Your Ref
EG/46/18/HH
Our Ref
PLAN-024201
Date
06/09/2018

Proposal: Alterations and single storey rear extension.
Site: 17 Orchard Way, Barnham, PO22 0HP.
EG/46/18/HH

Southern Water MapGuide Browser

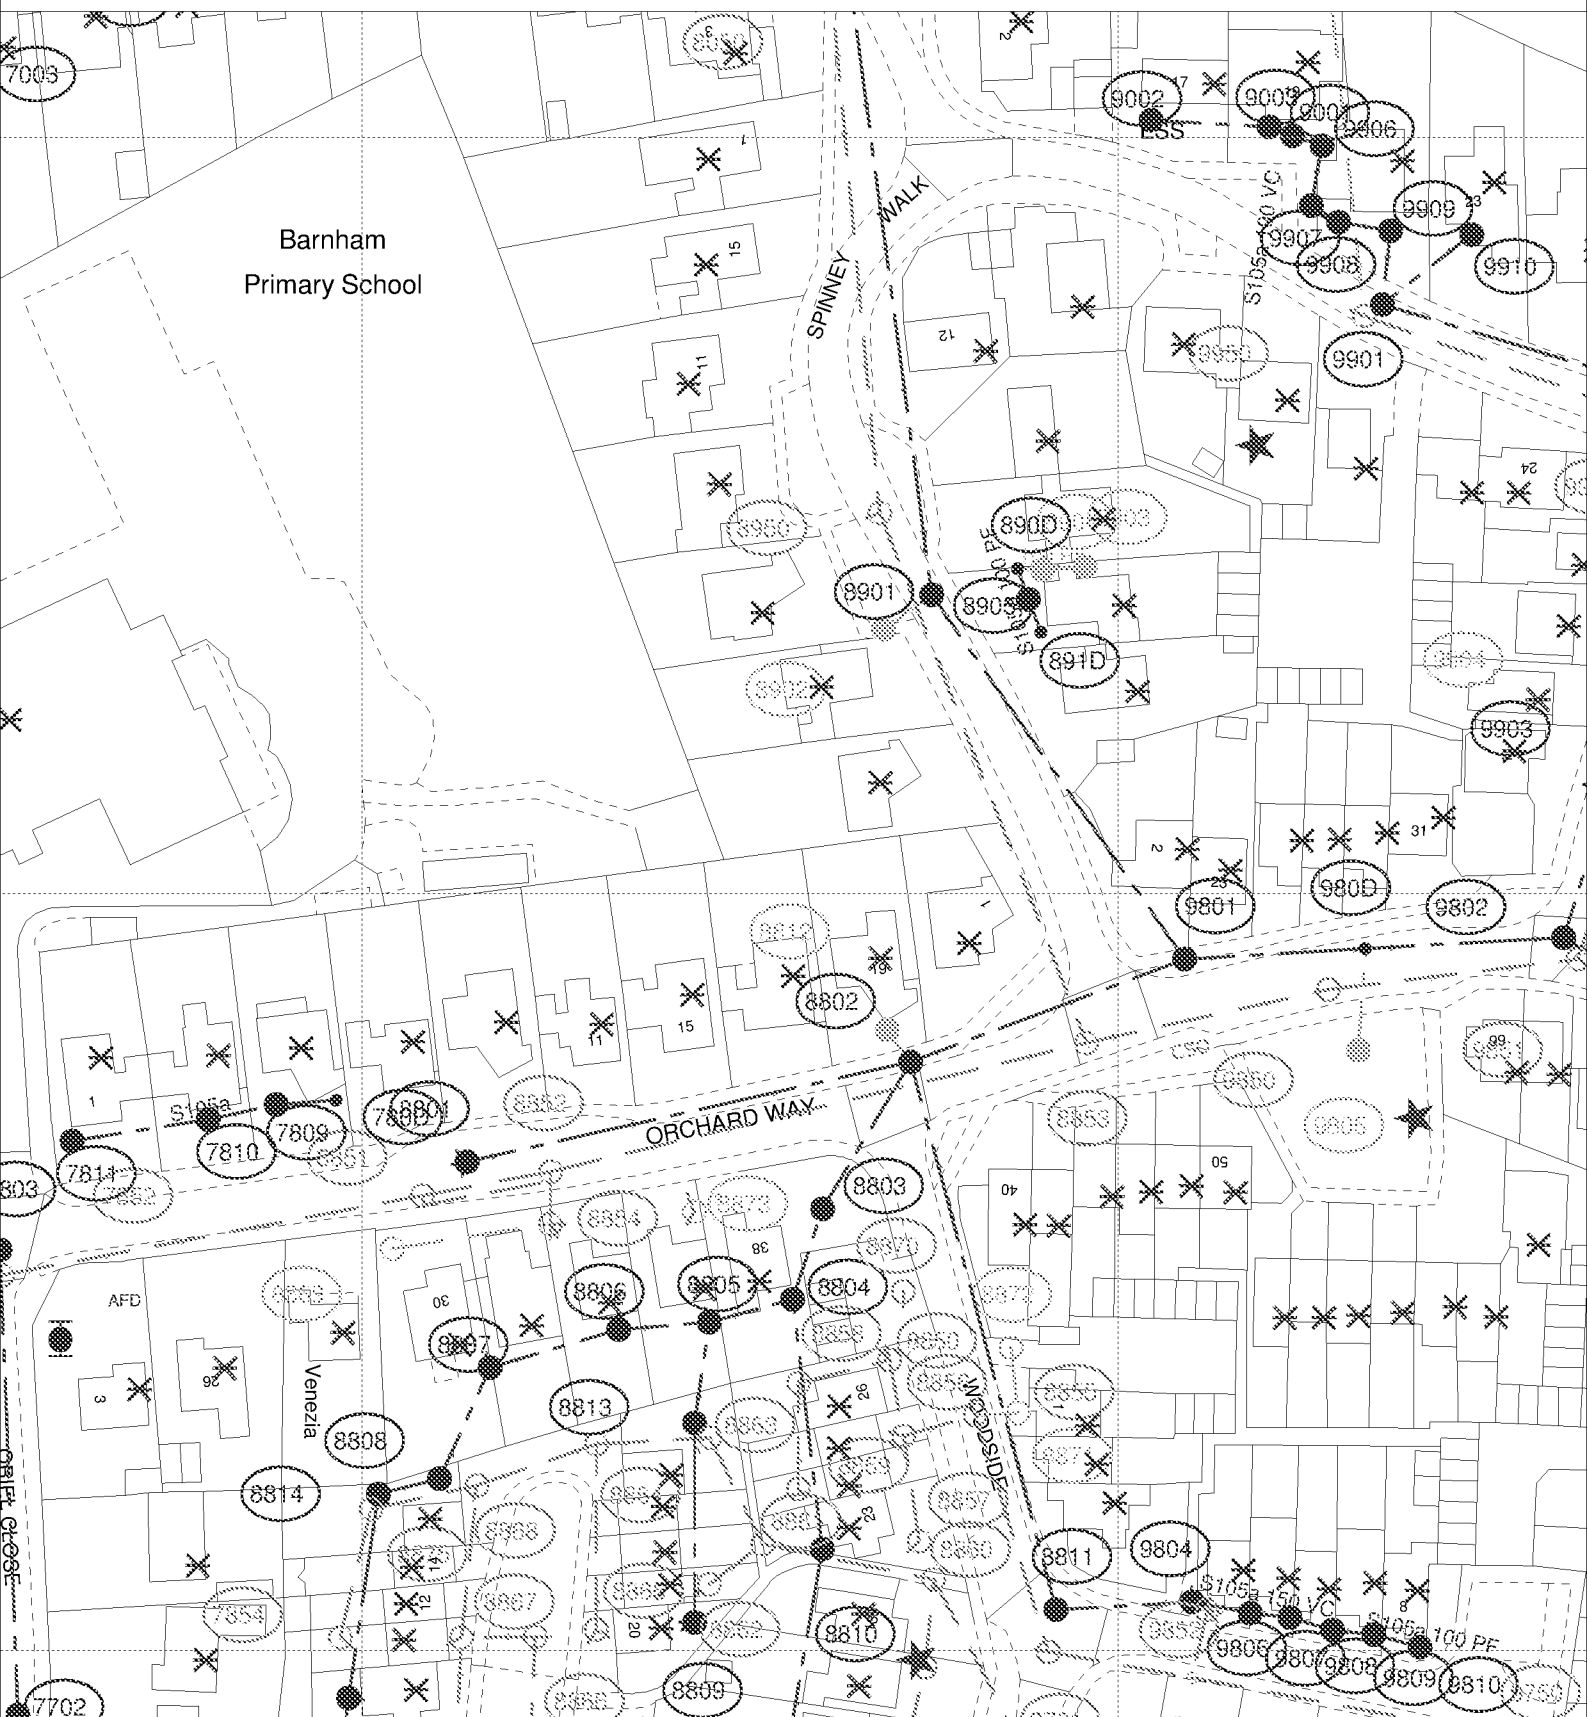
Due to changes in legislation that came in to force on 1st October 2011 regarding the future ownership of sewers it is possible that a sewer now deemed to be public could be crossing the above property. Therefore, should any sewer be found during construction works, an investigation of the sewer will be required to ascertain its condition, the number of properties served, and potential means of access before any further works commence on site.

The applicant is advised to discuss the matter further with Southern Water, Sparrowgrove House, Sparrowgrove, Otterbourne, Hampshire SO21 2SW (Tel: 0300 300 3000) or www.southernwater.co.uk.
